Riverfront Phase IIB Fort Wayne, IN

ADDENDUM #1

October 7, 2024

ADDENDUM NO. 1

NOTE: This is not a re-issuance or a new sheet, it is simply red-line mark-ups to try and help provide further clarification for Bid Item's #1 & #4 where their scopes of work start and stop for backfilling.

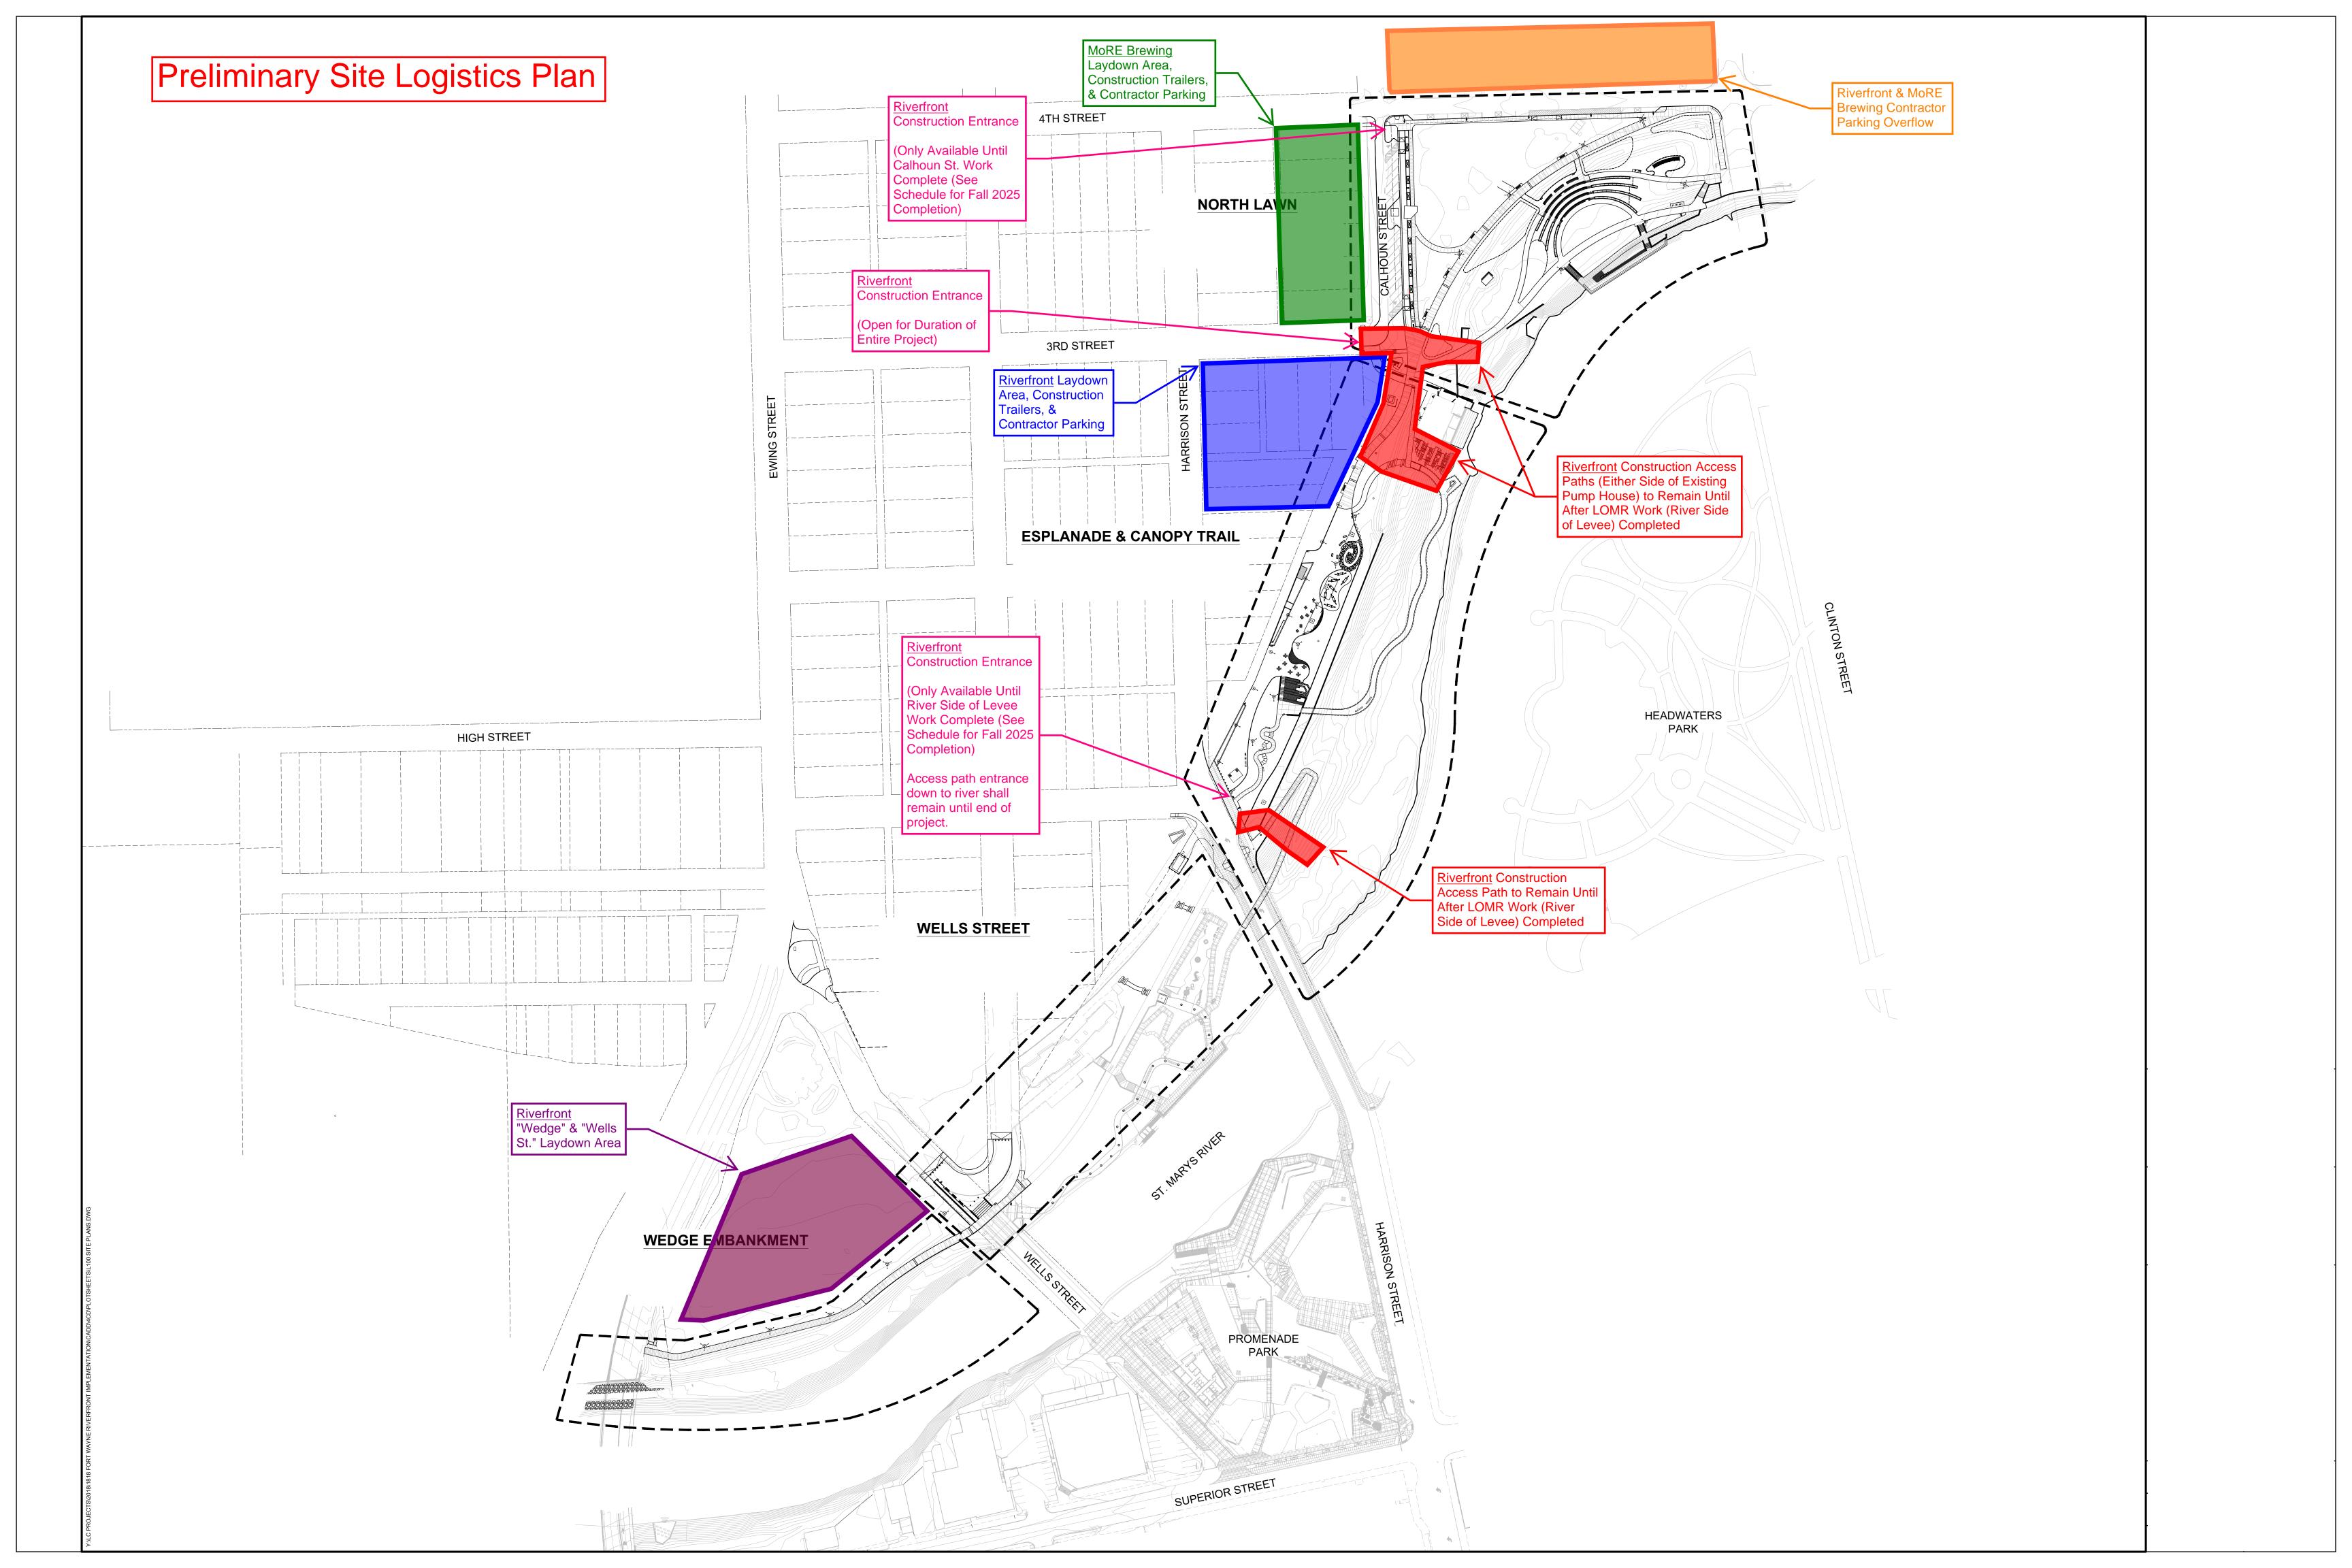
NOTE: This is not a re-issuance or a new sheet, it is simply red-line mark-ups to try and help provide further clarification for Bid Item's #1 & #4 where their scopes of work start and stop for backfilling.

Yearly River Levels

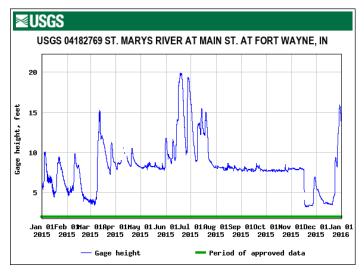
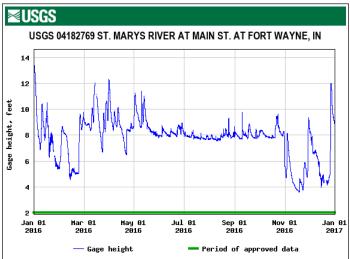
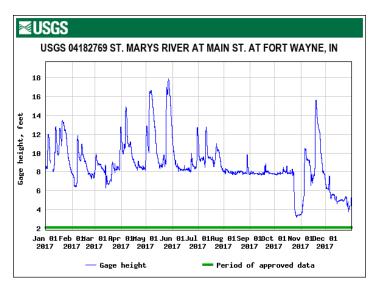
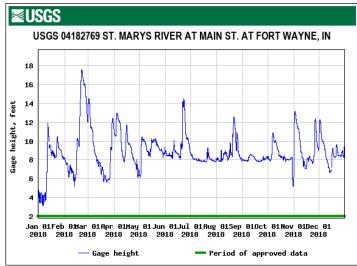
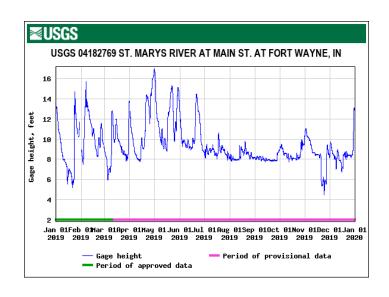
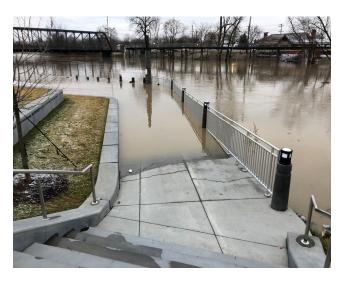
- 9) Q: The drawings do not define reinforcing for concrete pathways, please clarify what should be used.
 - A: See revised L600 Addendum #1
- 10) Q: Does the design team have river depths/history available?

- A: Yes. See two attached documents
 - i. Yearly river levels 2015-2019
 - ii. Yearly High Water Percentages by Elevation.xls
